**Hydrology Study Submittal Checklist and Application**

Hydrology Study Title SNWA River Mountain Solar Date 04-21-2015

Southern Nevada Water  
Authority River Mountains  
Solar

Subject: Technical Drainage Study Review Comment Responses

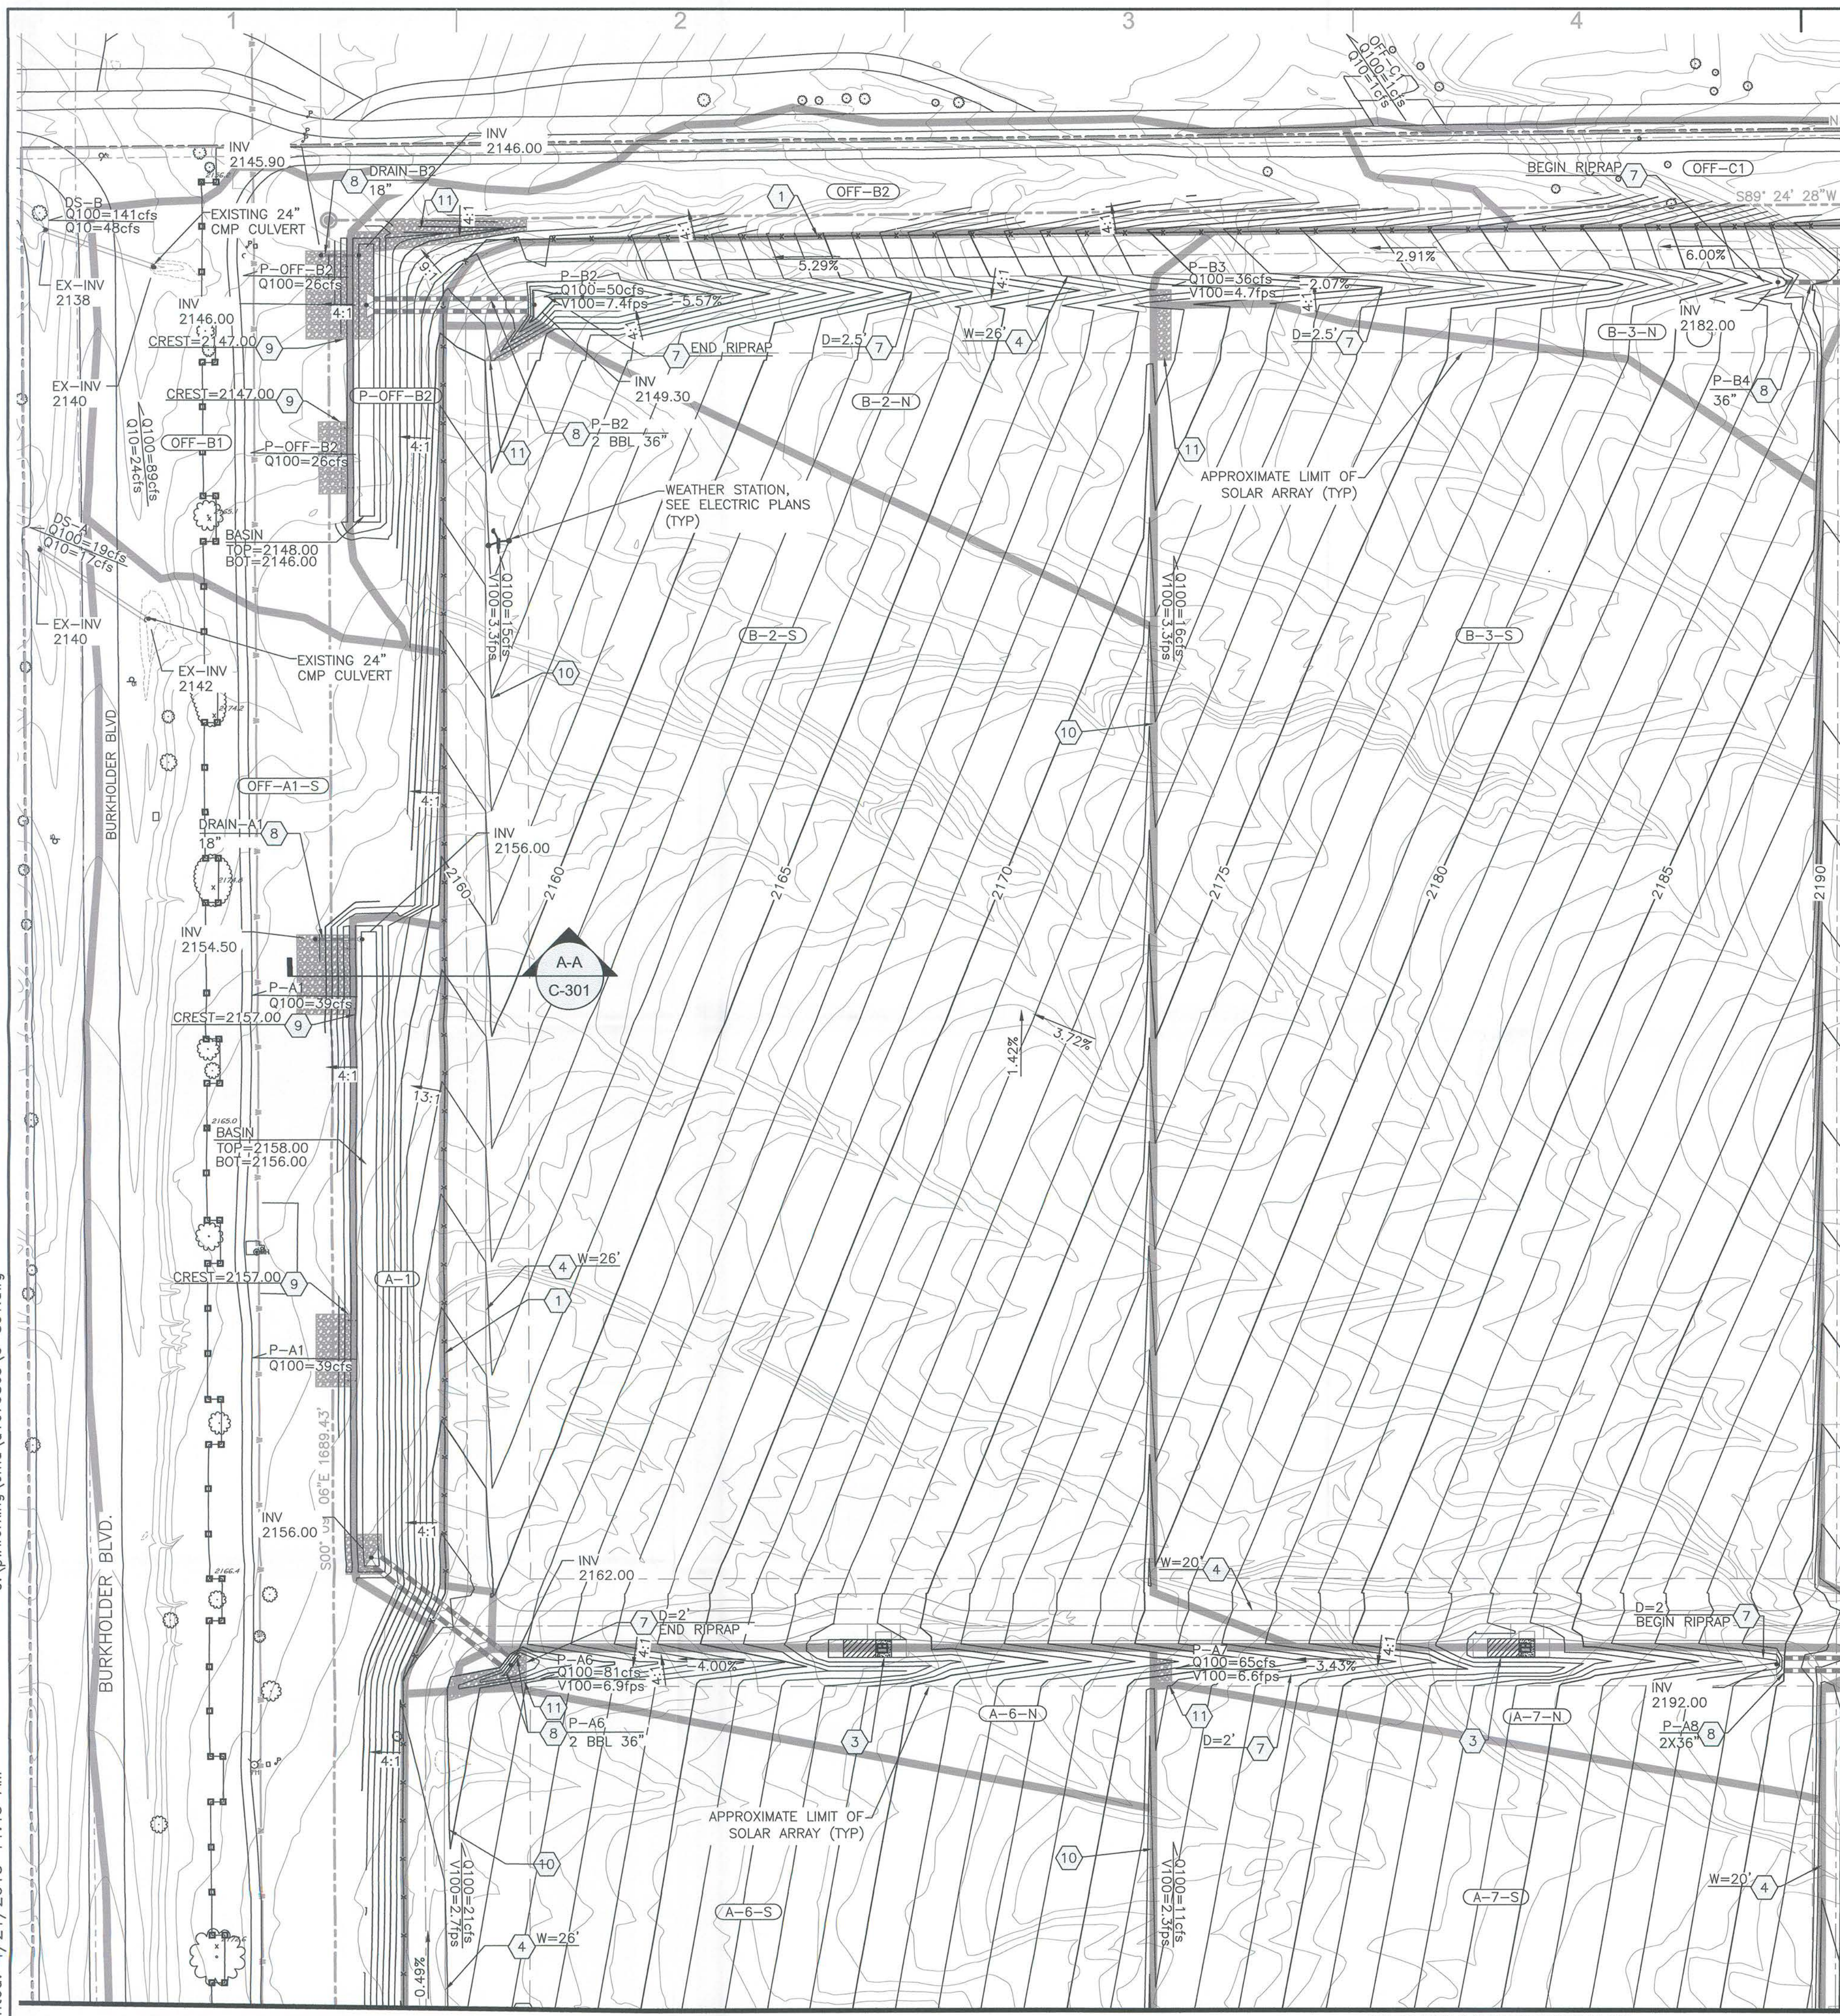
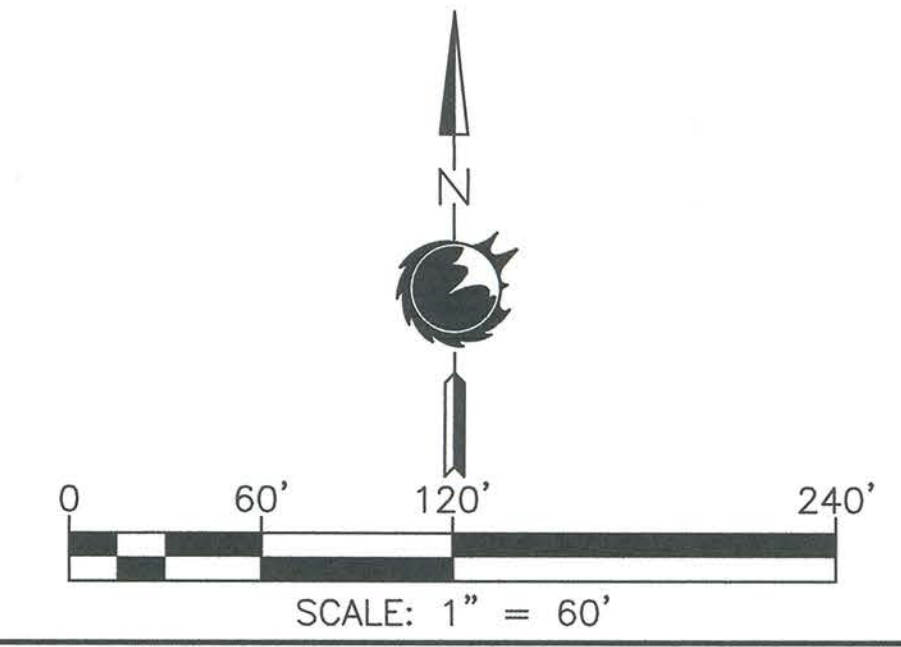
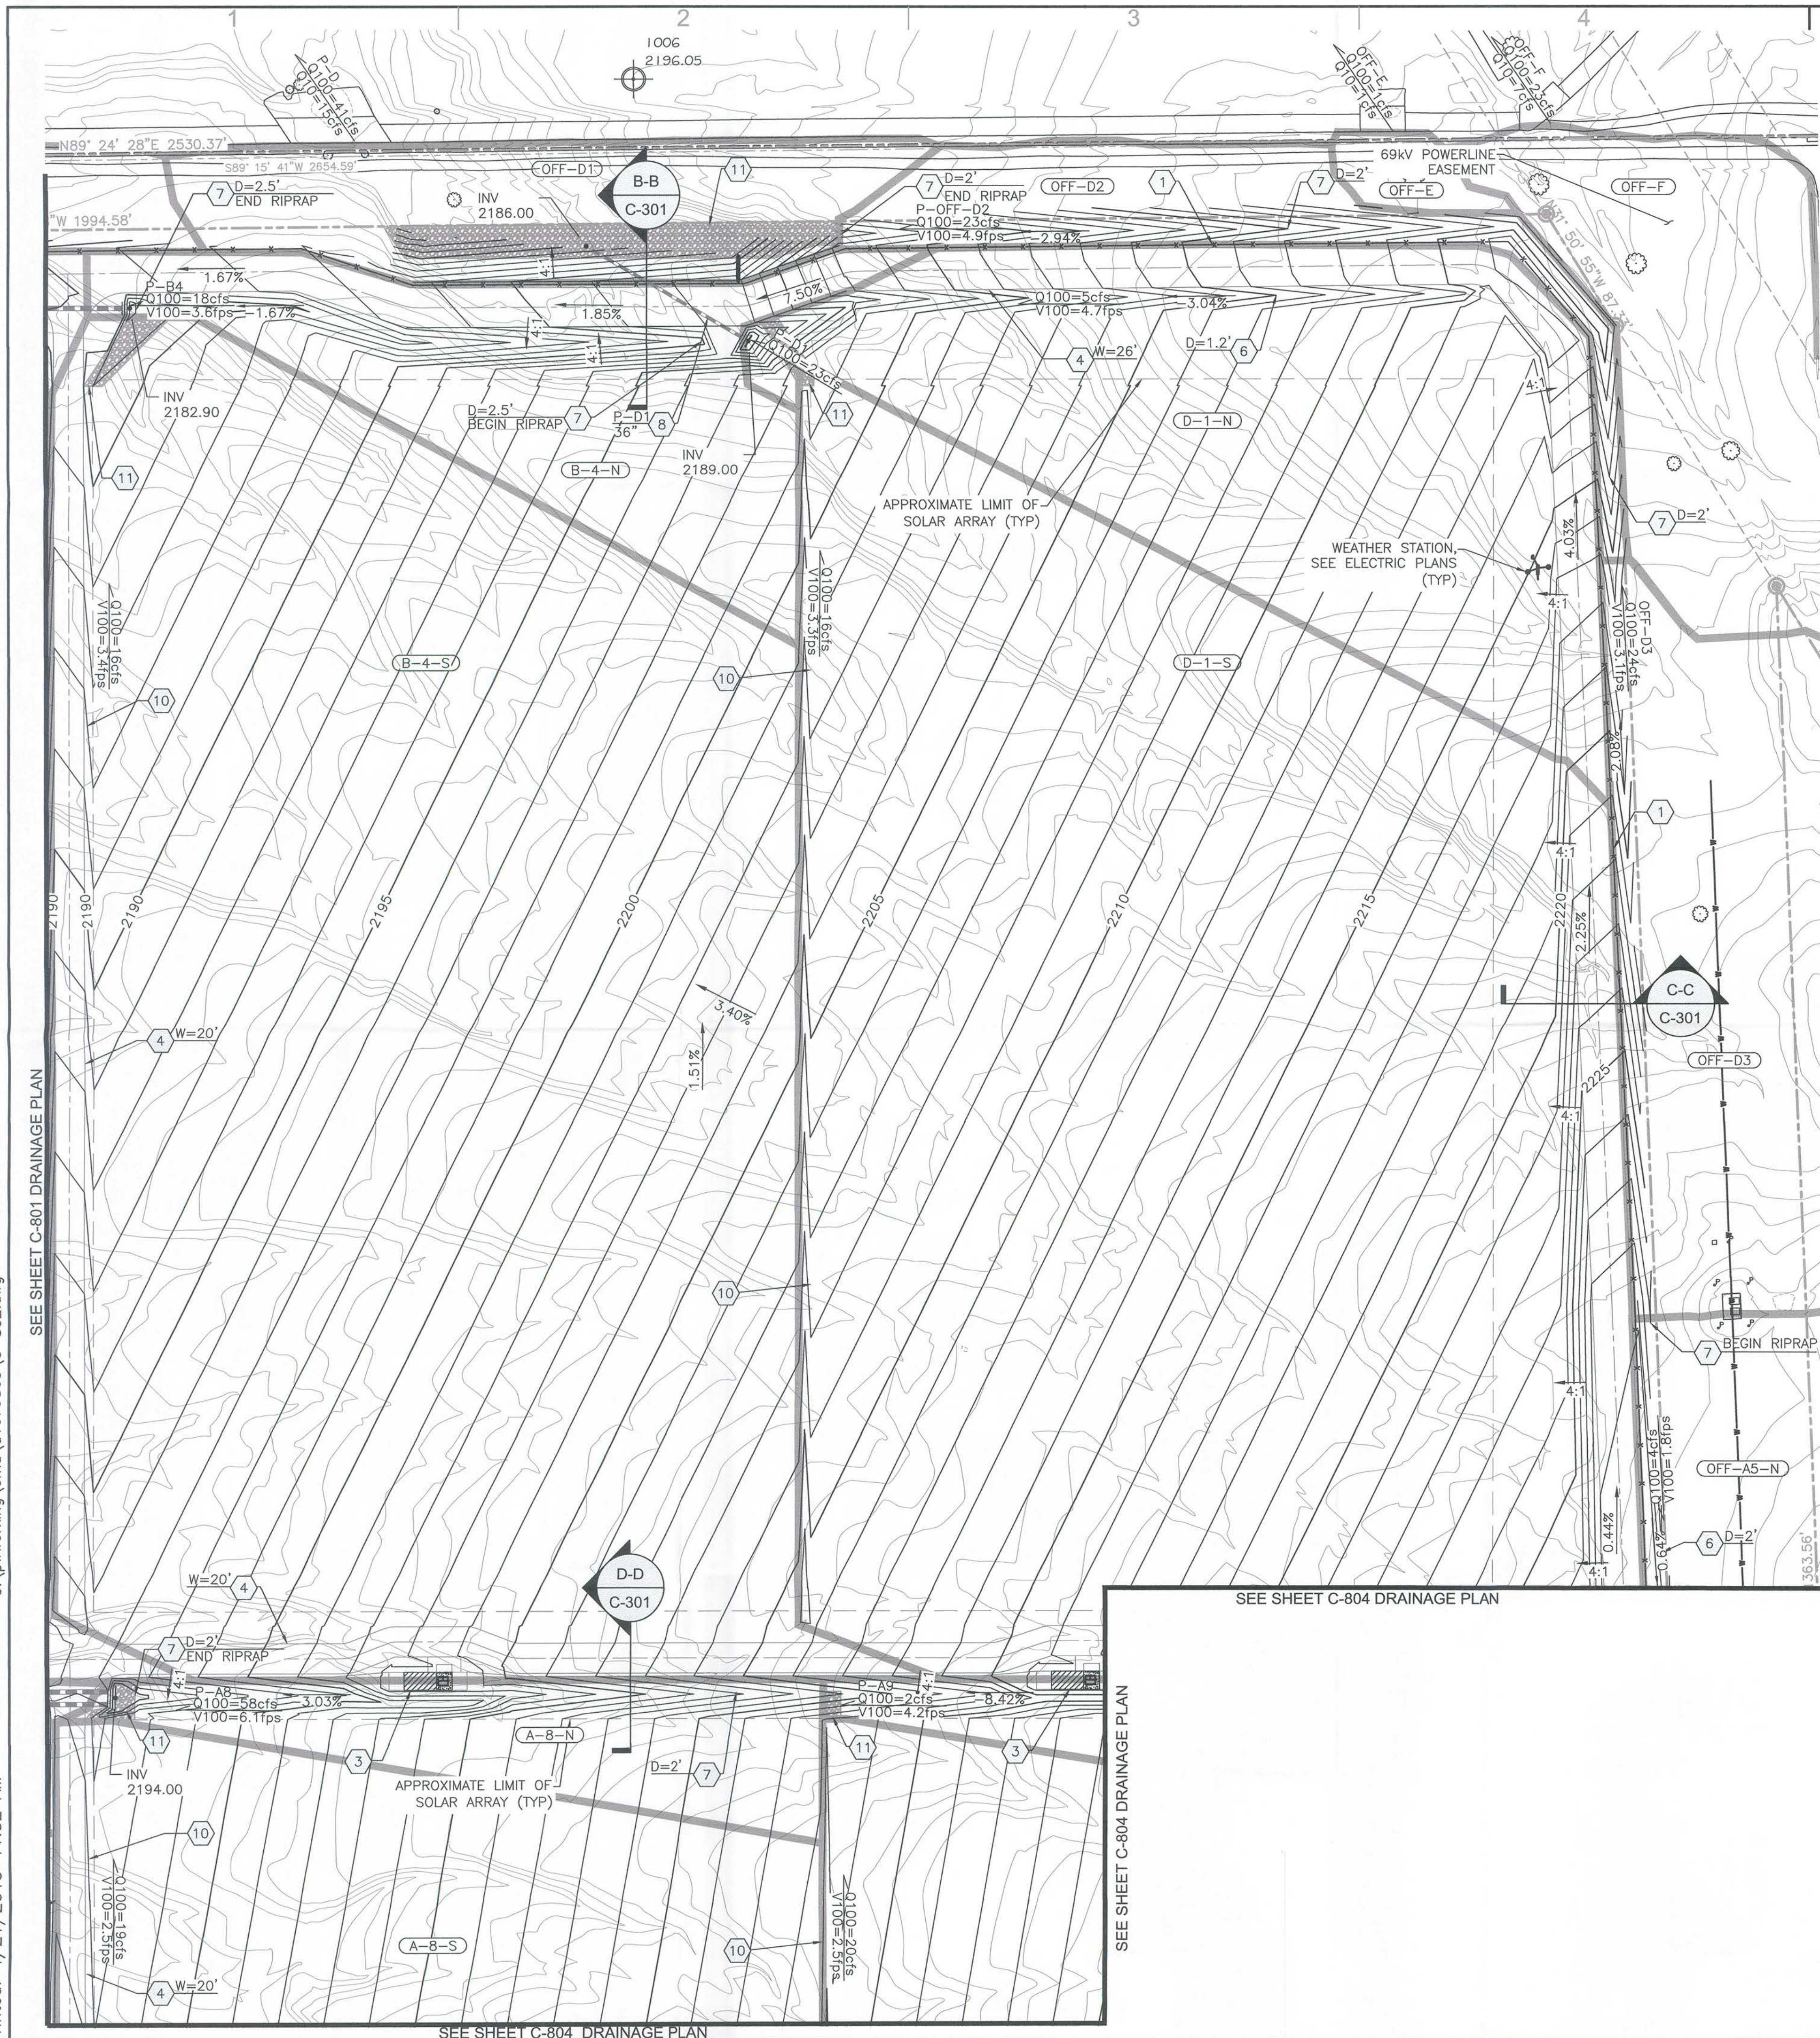
14. The following grading plan comments must be addressed with the next submittal:
- a. Sheet C-801: Revise the leader line for construction note 8 at P-A 10 to be directed to the single culvert

- b. Sheet C-801: Add the width to construction note 4 in subbasin A-10

- c. Sheet C-801: Revise construction note to refer to Detail 3

*Updated to show road width of 20'.*

SHEET NO.:  
**C-802**

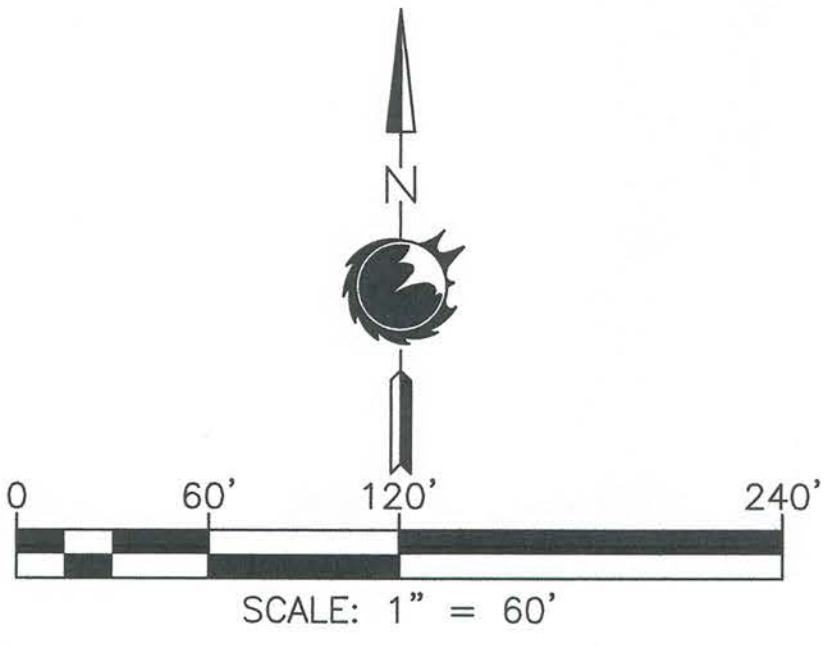
2. The project proposes rip rap within what appears to be a power line easement at the northeast corner of the project (see sheet C-802). Documentation must be provided which indicates that this is allowed within the easement or written permission must be obtained from the easement grantee.

- d. Sheet C-802: Provide a construction note for the rip rap in subbasin OFF-D1

- e. Sheet C-802: Provide construction note 7 for the channel upstream of OFF-D3 to indicate rip rap to be in agreement with the calculations

*Riprap has been removed from this area. Plans have been updated to reflect this change (Sheet C-802).*
